# CITY OF ALBUQUERQUE

**RE: UHaul 4<sup>th</sup> St & I40  
2217 4<sup>th</sup> St NW  
Revised Conceptual Grading and Drainage Plan  
Engineer's Stamp Date: 09/11/19  
Hydrology File: H14D110**

Based upon the information provided in your submittal received 09/11/2019, the Revised Conceptual Grading & Drainage Plan and Drainage Report are approved for action by the DRB on Site Plan for Building Permit.

SHEET TITLE: CONCEPTUAL G&D PLAN

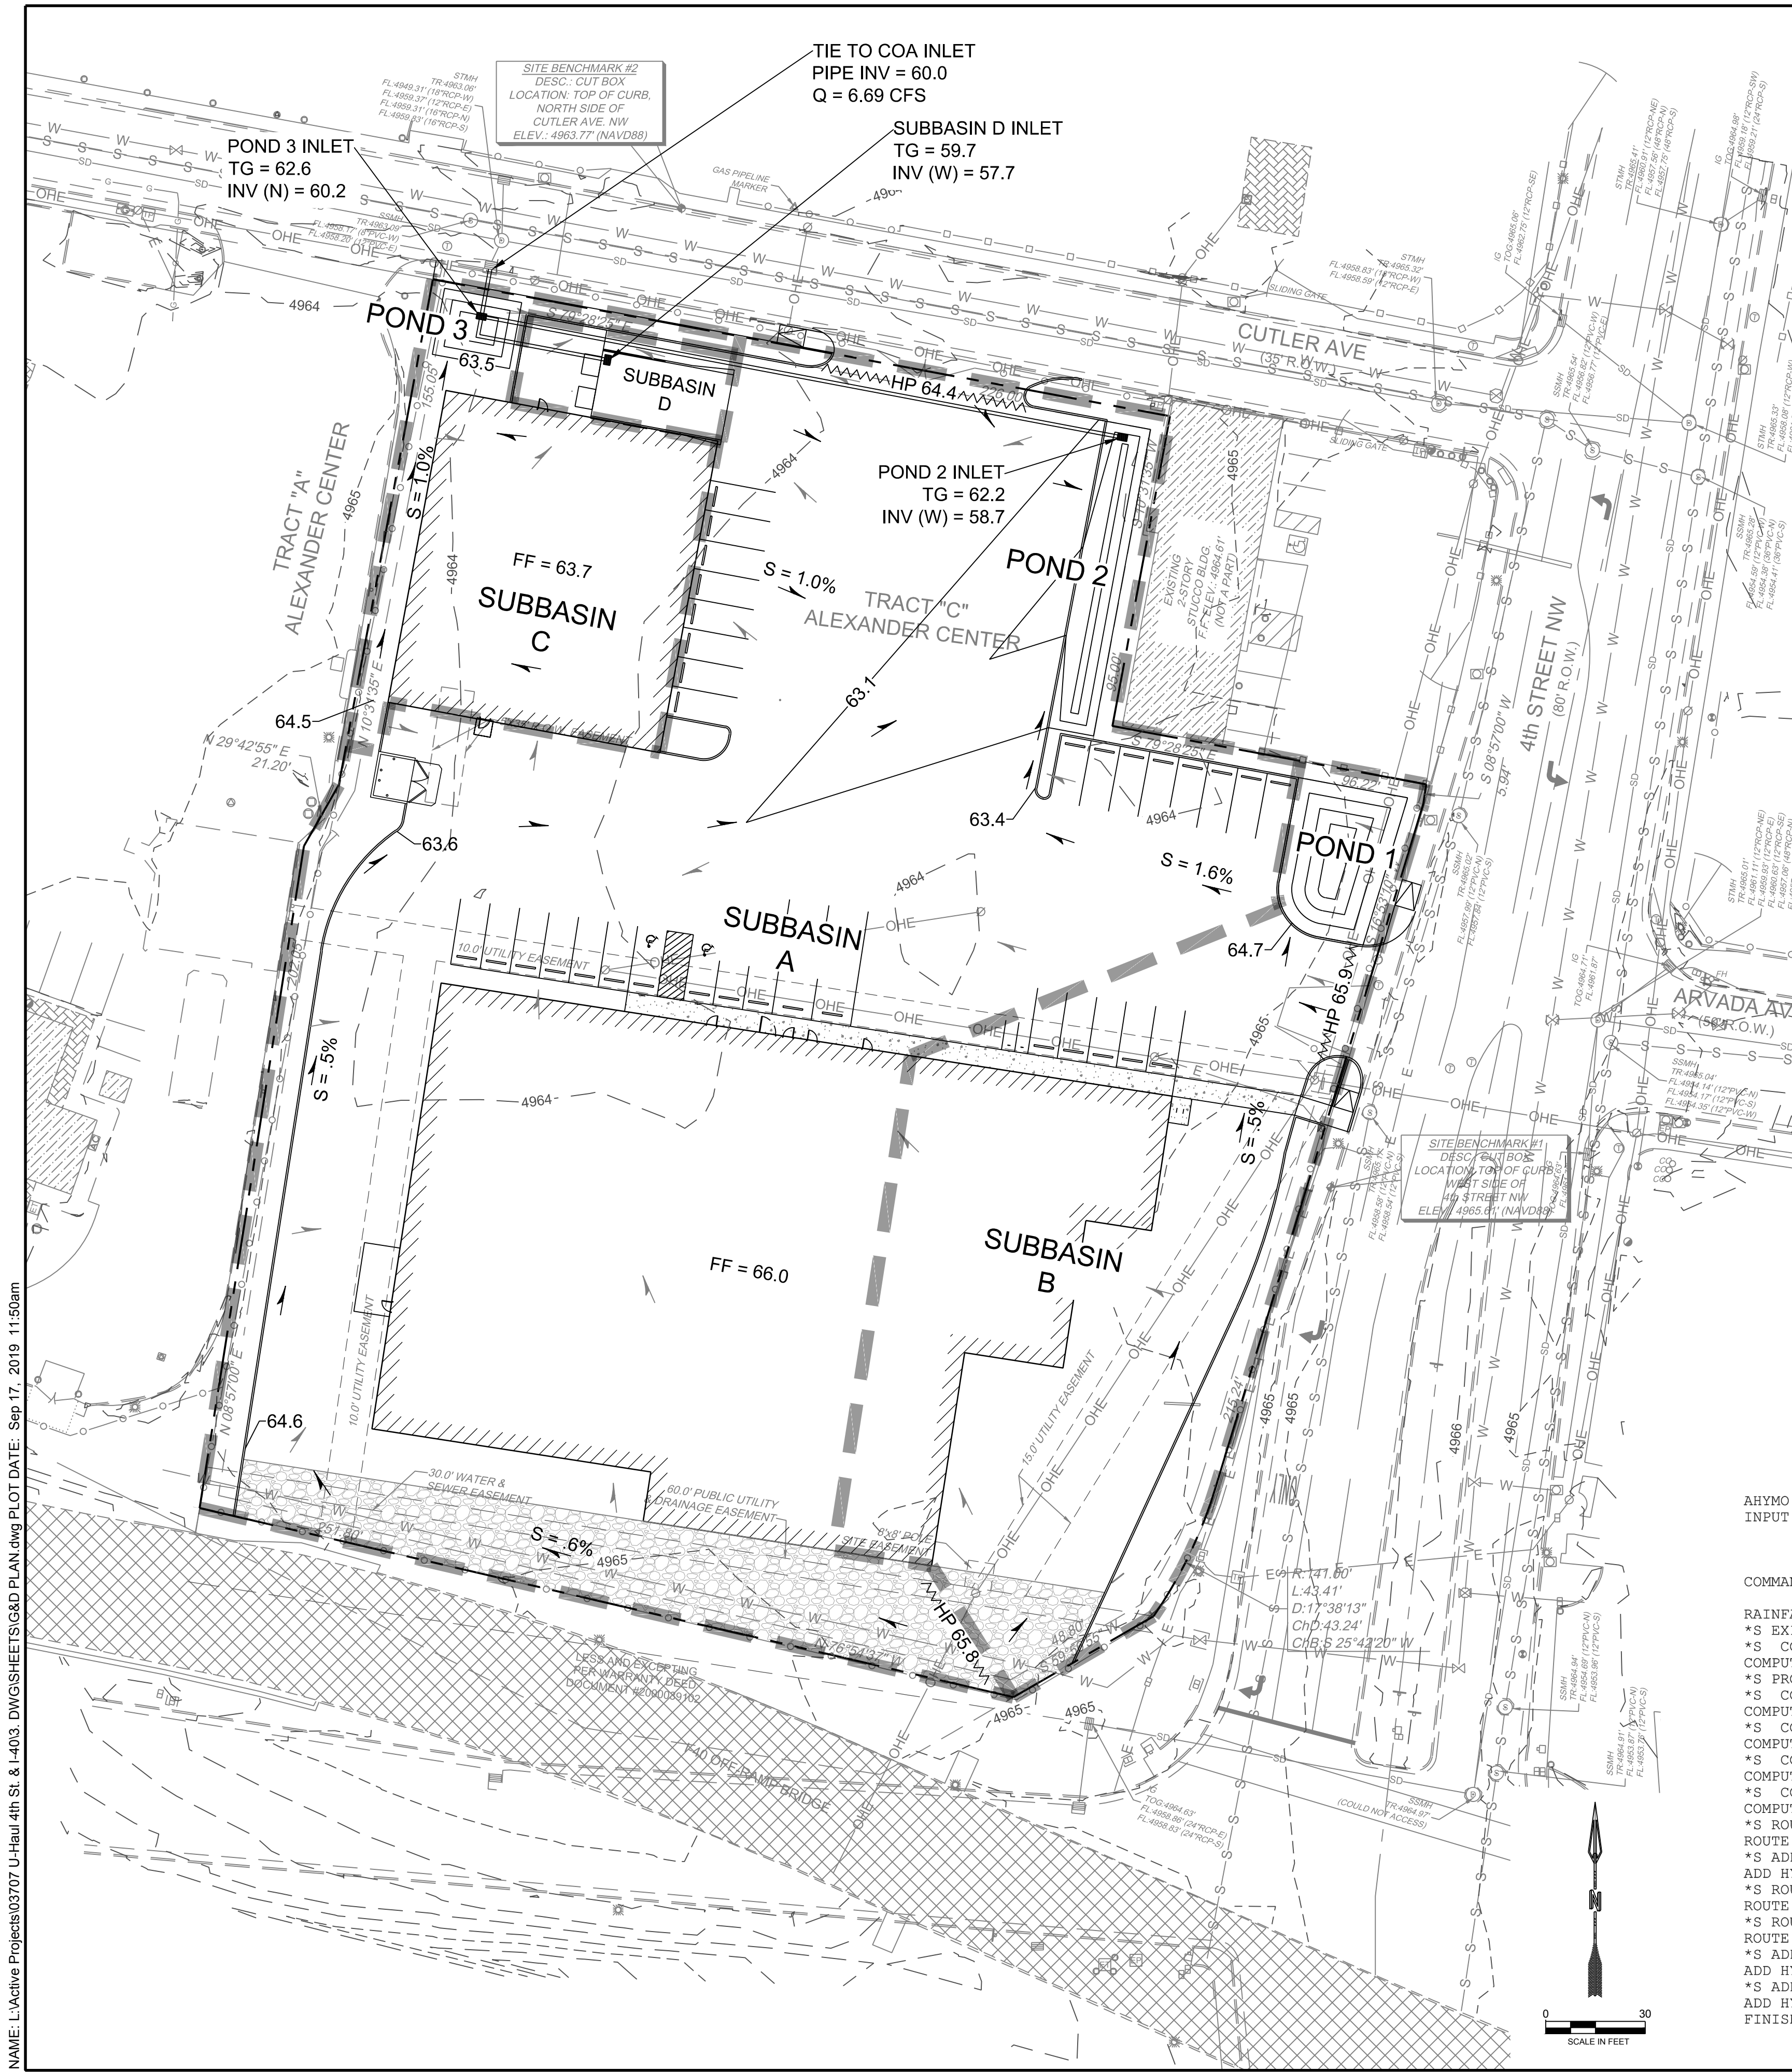
Also as a reminder, please provide a Drainage Covenant for the proposed Stormwater Quality Pond per Chapter 17 of the DPM prior to Permanent Release of Occupancy. Please submit this on the 4th floor of Plaza de Sol. A \$25 fee will be required.
